APEX DESIGN BUILD PRESENTS
OFFICE BUILDING RENOVATION
SHETH DERMATOLOGY
9131 W. 151ST-ORLAND PARK, 60462

15022
A1.0

2 Site - Callout 1
1 1/2" = 1'-0"

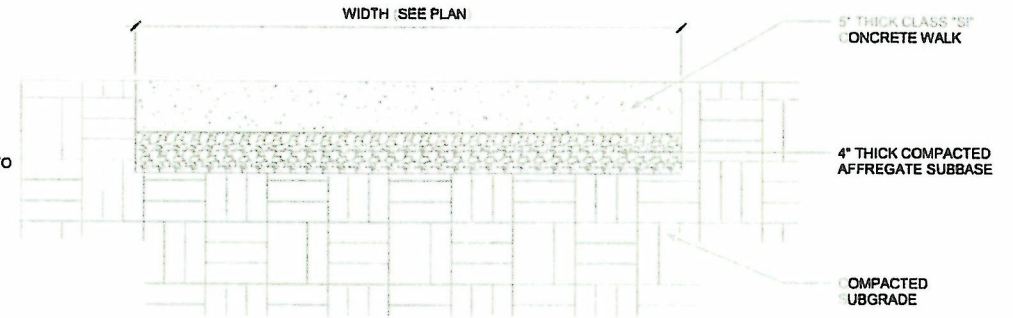
INDICATES PAVEMENT AREAS THAT SHOULD BE PATCHED (REMOVE & REPLACE BROKEN ASPHALT).

CANNOT FILL ANY HOLES HERE, AS PAVEMENT IS ALL CRUMBLING

PATCH PAVEMENT W/IN LIMITS OF PROPERTY

INOPERABLE LIGHT POLE

ABOUT 11FT WIDTH OF ASPHALT TO BE REPLACED

- NOTICED SEVERAL PARKING BLOCKS/WHEEL STOPS AROUND PARKING LOT. SINCE THE LOT IS CURBED, IT WOULD SEEM THESE BLOCKS SHOULD BE REMOVED.
- 3 SICK TREES @ SOUTH PROPERTY SHOULD BE REMOVED.
- REMOVE INOPERABLE LIGHT POLE & BASE FOUNDATION.

YES

YES
